Jan 26 2010

## 2010 product update new bath fan improvements

### 1 - INCREASED AIRFLOW, QUIETER OPERATION

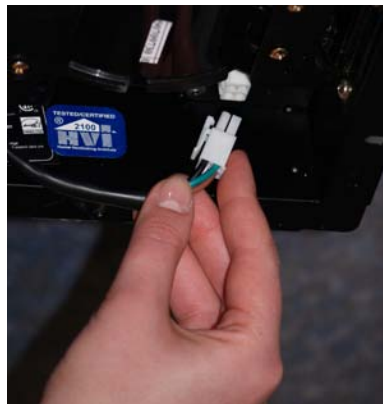
Abreezo is reintroducing the weighted back draft damper which is recessed inside the fan body collar. The weighted damper will provide less resistance during fan operation offering a more fluent air flow and quieter operation.

### 4 - NEW USER FRIENDLY PACKAGING

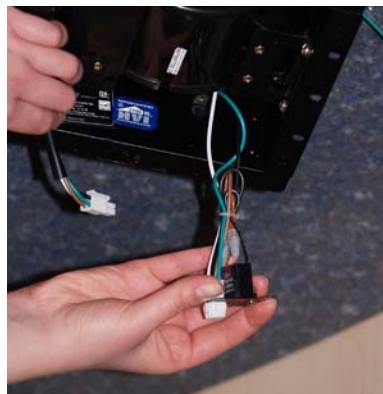
A new message has been put on the protective cardboard insert instructing the contractor to remove the cardboard and connect the Molex connector prior to placing the grill on the fan when construction and painting are complete.
